HOSHIZAKI AMERICA, INC.

SERVICE BULLETIN

SB14-0005

SUBJECT: Flaker Timer Board 437305-01 & 437305-02 No Longer Available

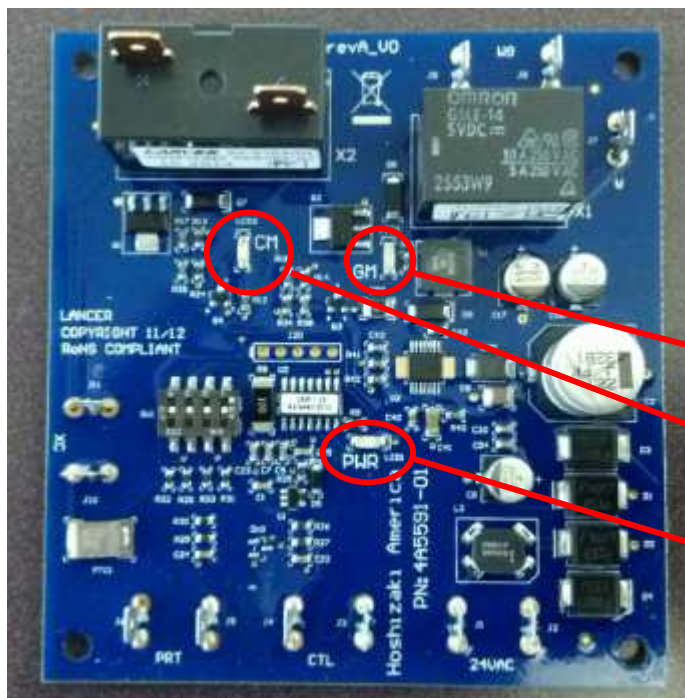
Previous timer board's 437305-01 & 437305-02 now subs to new timer board 4A5591-01. Although 4A5591-01 has additional features, the operational sequence is the same as 437305-01&-02 and terminal connections remain the same. The new board has LED's to show the mode of operation and dip switches to adjust bin control shut down timing. This board is a universal replacement for part number 437305-01 & 02.

LED'S: The board has three LED's and they are labeled PWR [power], GM [gear motor] and CM [compressor motor]. The power LED will blink meaning power OK. The GM and CM LED'S will be lit meaning the component is in operation.

Dip Switches: This board has four dip switches. At this time the only adjustment will be dip switch #1. For all flaker models the dip switch #1 will be in the ON position and 2-4 will be OFF. For the DCM-270BAH operation all four dip switches will be in the OFF position.

GM LED lights when Gear Motor is energized.

CM LED lights when Compressor is energized.

PWR LED blinks when Power is OK

Dip Switches	1	2	3	4
DCM-270BAH	OFF	OFF	OFF	OFF
All Other Flakers	ON	OFF	OFF	OFF
